**REQUEST FOR FURTHER INFORMATION IN ACCORDANCE WITH SECTION 92 OF THE
RESOURCE MANAGEMENT ACT 1991**

Application numbers:	BUN60436879 (Council Bundle Reference) LUC60436940 (s9 Landuse Consent) DIS60436941 (s14 Discharge Consent)
Applicant:	Precinct Properties Wynyard Limited
Proposal:	Demolition of existing buildings, including a character supporting, construction of mixed-use development, including 135 residential units, five commercial tenancies, 106 car parks and 143 cycle parks, and associated enabling works
Site address:	198-202 Dominion Road, 214-222 Dominion Road and 113-117 Valley Road, Mount Eden

SECTION 92 REQUEST

To: Dylan Pope
From: Andrew Henderson Principal Urban Designer
Date: 25.09.24
Address: 200 Dominion Road Mount Eden
Application #: BUN60436879

Figure 1: Vehicle crossing arrangement at Valley Road. Source: Sheet RC-054 Rev C of the Architecture Plan dated 27 August 2024.

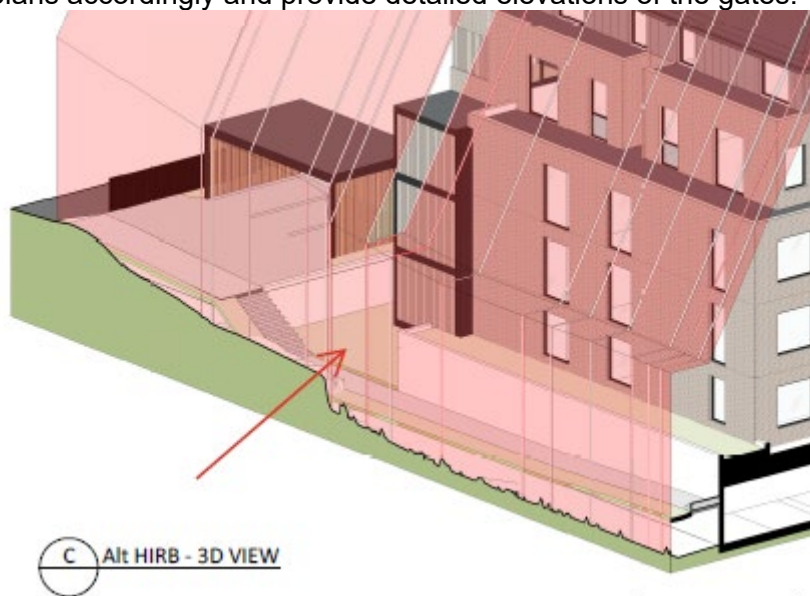
5. Section 4.5 notes that an access gate is setback 10.2m from the property boundary "to ensure queued vehicles are contained on-site and not extend over the pedestrian footpaths or onto the arterial roads.". Upon review of the architecture plans, AT notes that columns are proposed on either side of the vehicle crossing, as shown in Figure 1 below. Given the scale of the development and the relatively high pedestrian traffic on Valley Road, AT considers that the proposed columns could potentially impede the visibility of exiting vehicles. Further, AT considers that the 10.2m setback could potentially allow exiting vehicles to pick up speed once the gate opens, resulting in pedestrian safety-related adverse effects. To ensure pedestrian safety at the vehicle crossing in accordance with E27.8.2 (11), please provide an assessment on how pedestrian safety and intervisibility will be ensured at the crossing and how any potential adverse effects could be avoided, remedied, or mitigated.

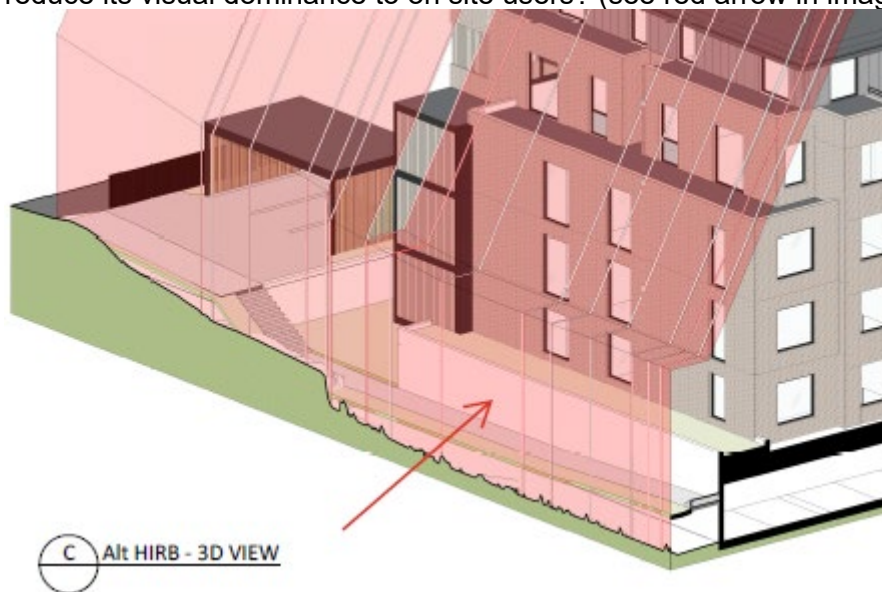
9. Please provide elevations and 360deg. perspectives of the proposed pavilion structure and identify any internal fit out proposed.
10. Please clarify the design of the wall facing the rear Carrick Street pedestrian access. This is currently not shown on the plan sets and will appear as a tall enclosing wall to a narrow width access. Will this provide any treatment to reduce its visual dominance to on site users? (see red arrow in image below)
